Inter-Office Memorandum  
Review & Comment

Date: August 15, 1979  
TSG-362

Subject: Guidance on Turbine Bypass Valve Operation

Reference: Control of Natural Circulation Using the Turbine Bypass Valves,  
J. P. Moore to R. C. Arnold, TSG-333, dated August 6, 1979

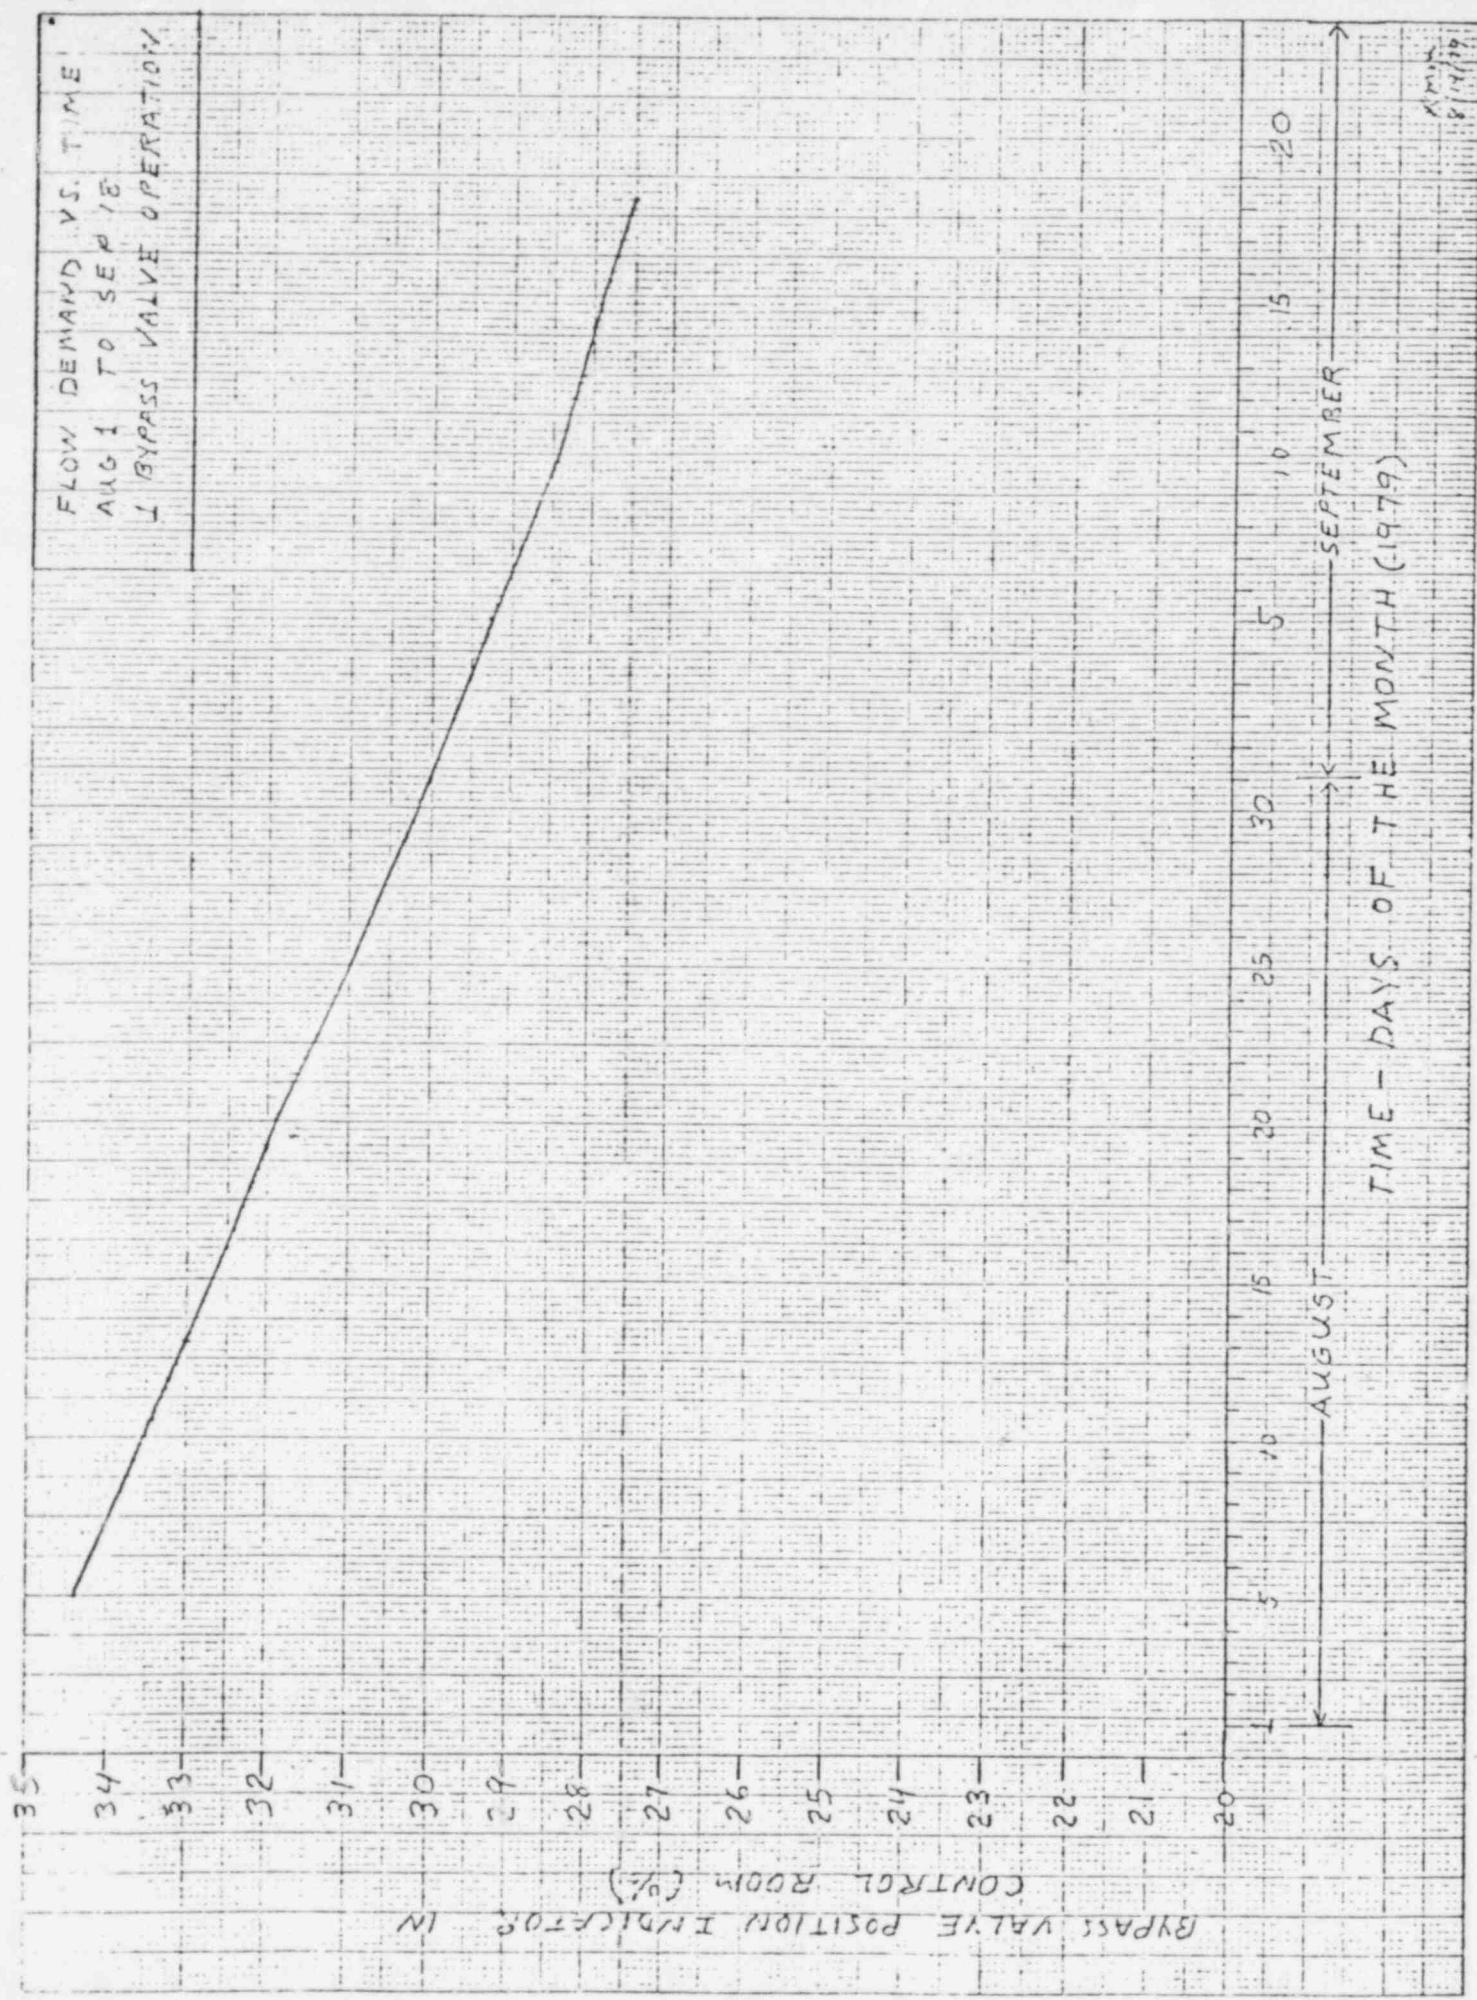
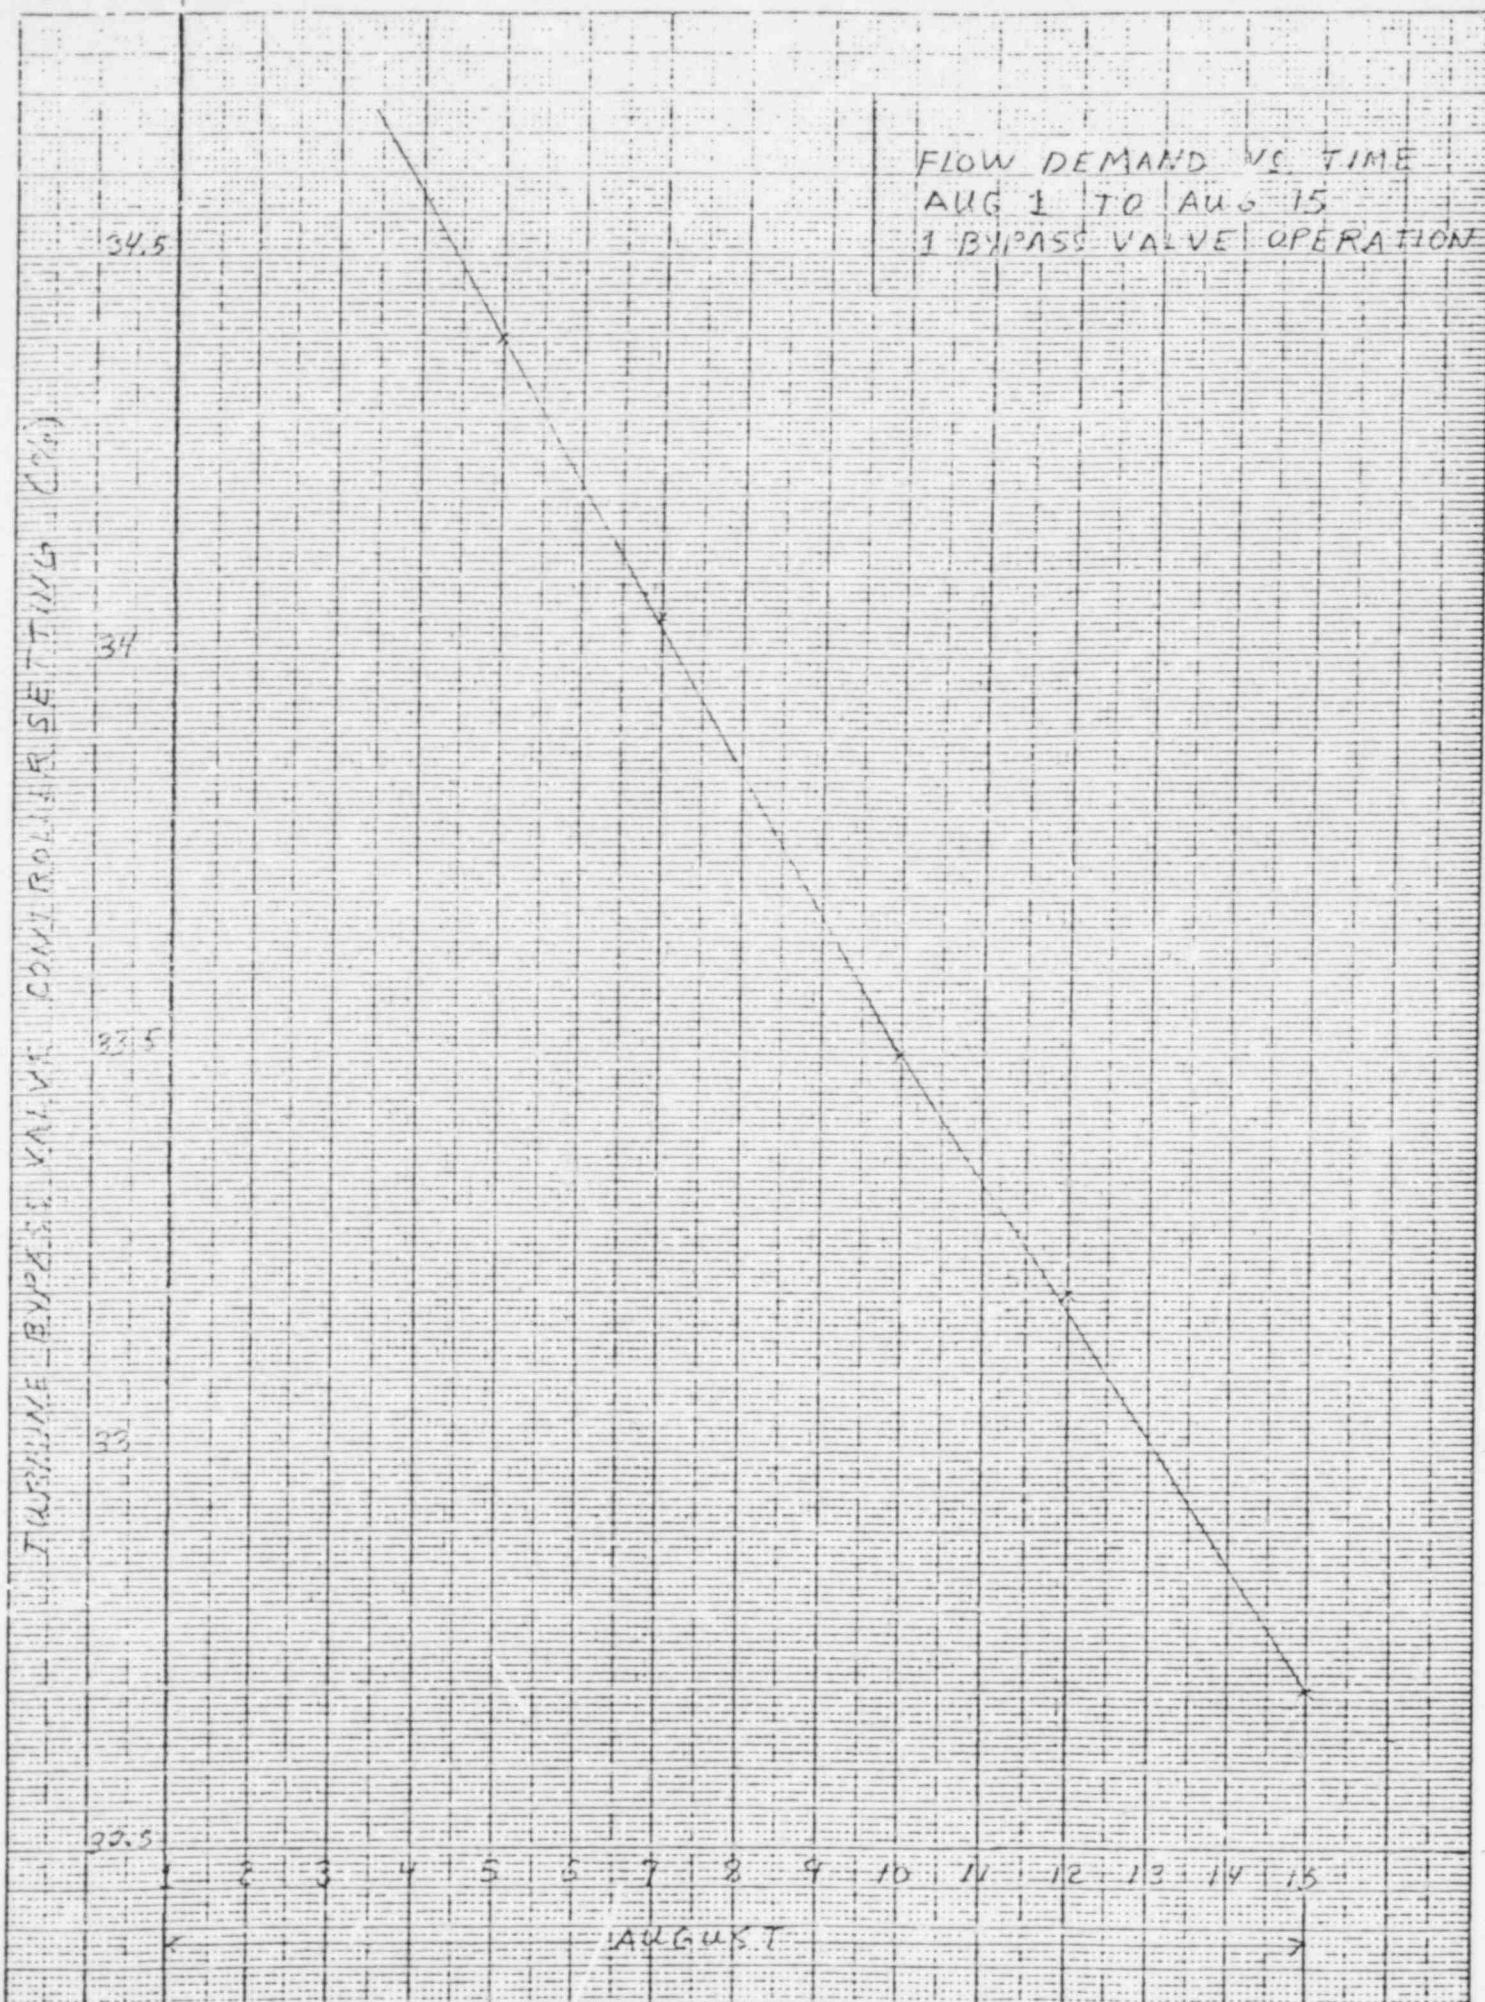
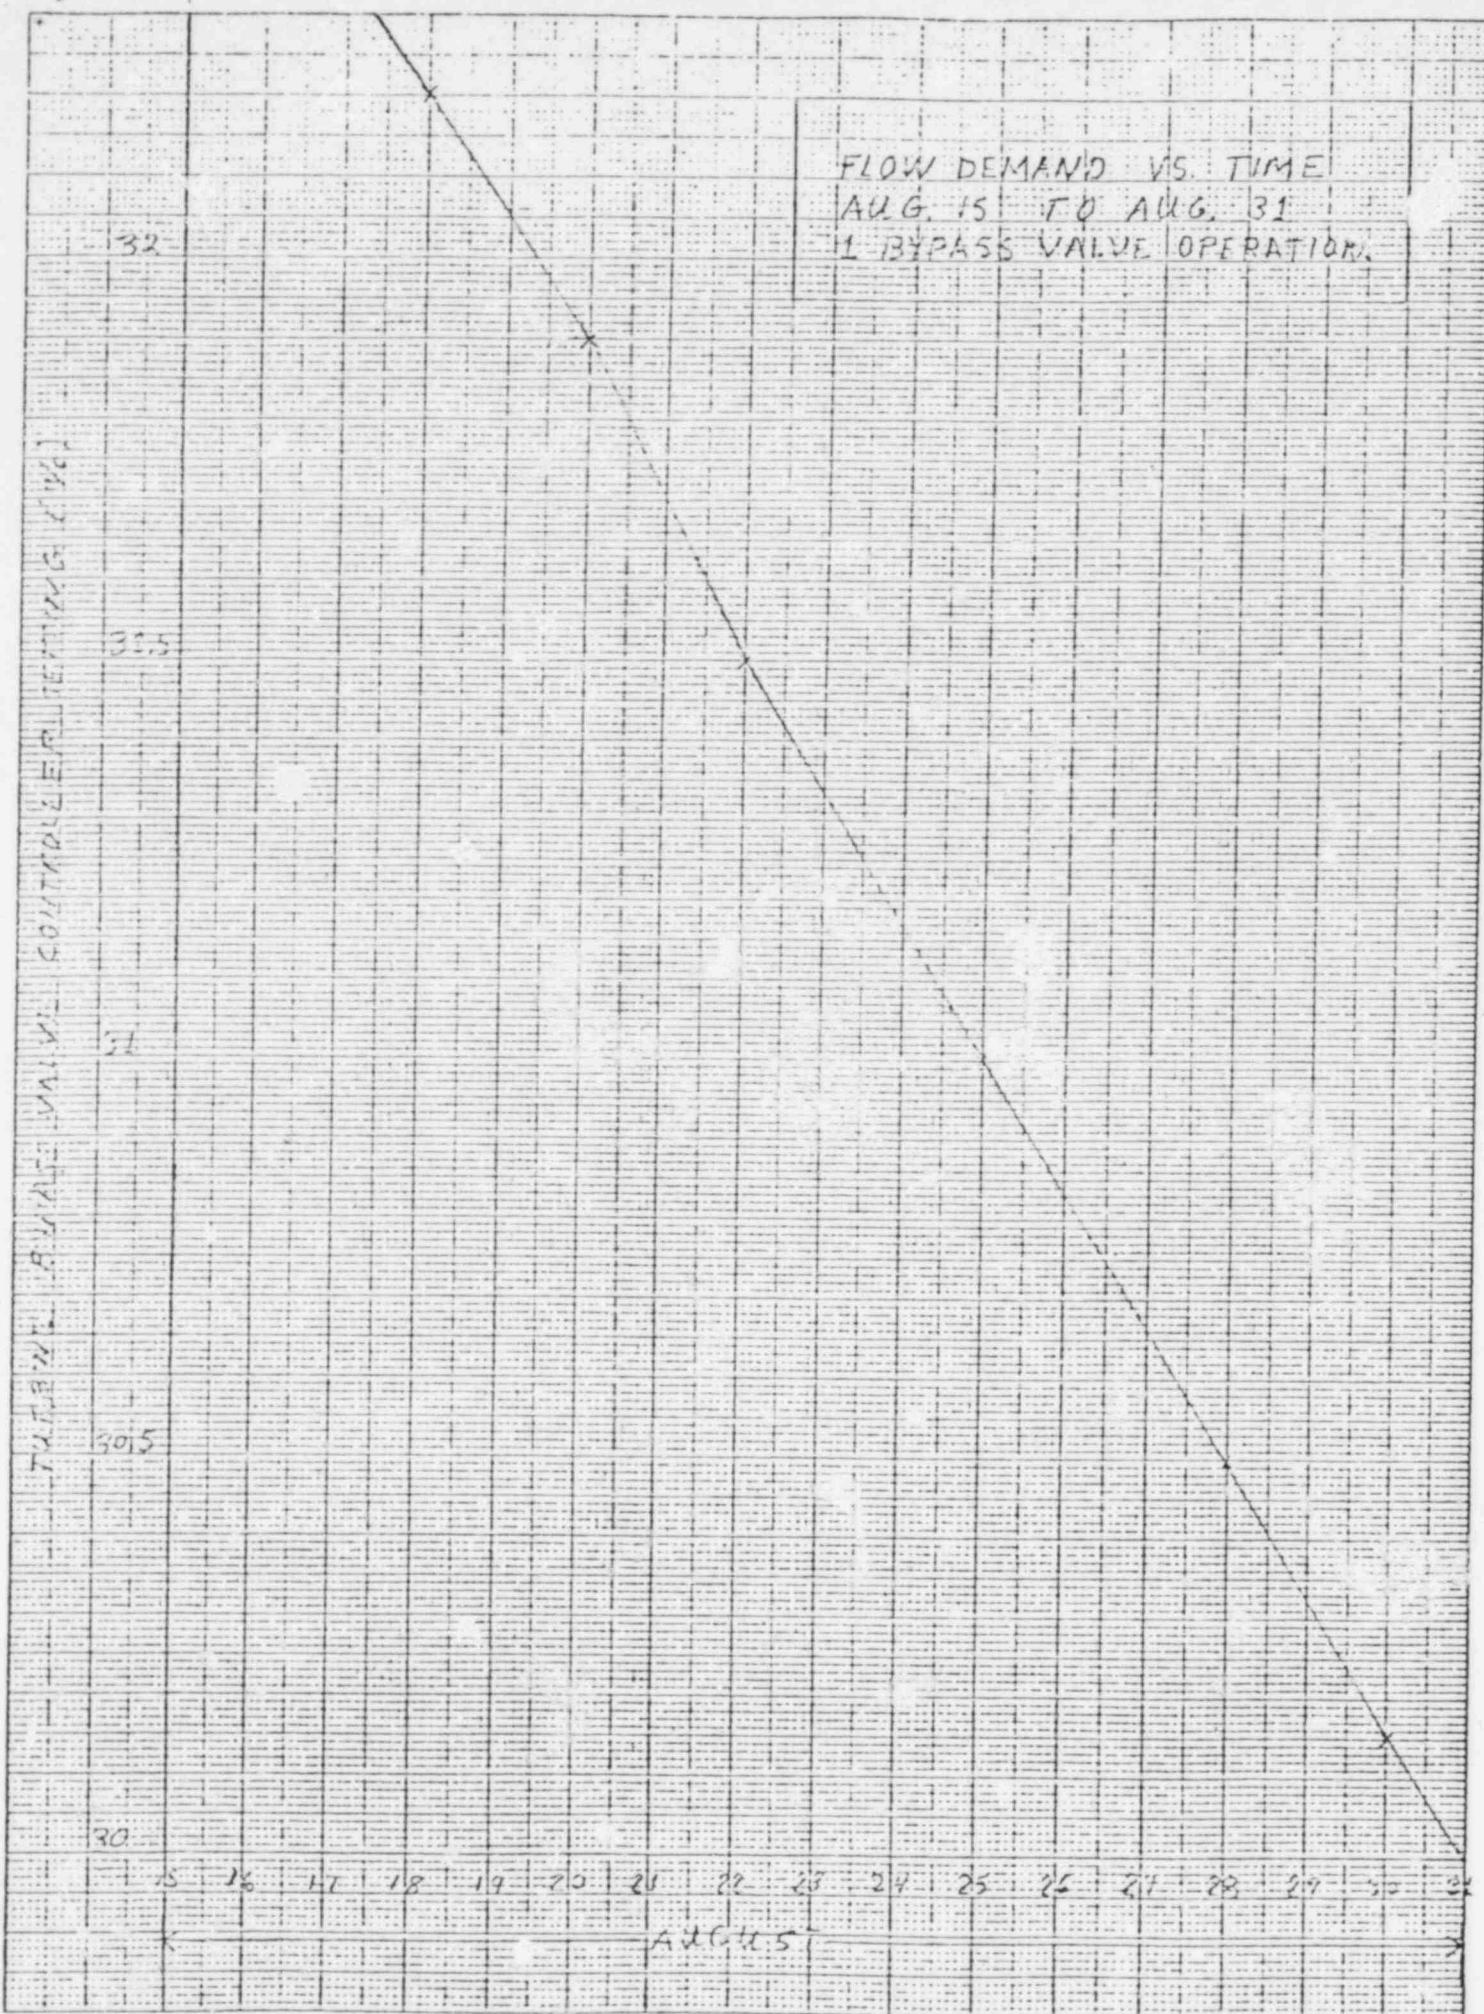
Attached are revised copies of the curves included with the reference. These curves have been biased by the difference between the calculated position and the actual position obtained after the transition had reached equilibrium. Use of these curves and the additional guidance provided above is recommended for turbine bypass valve operation.
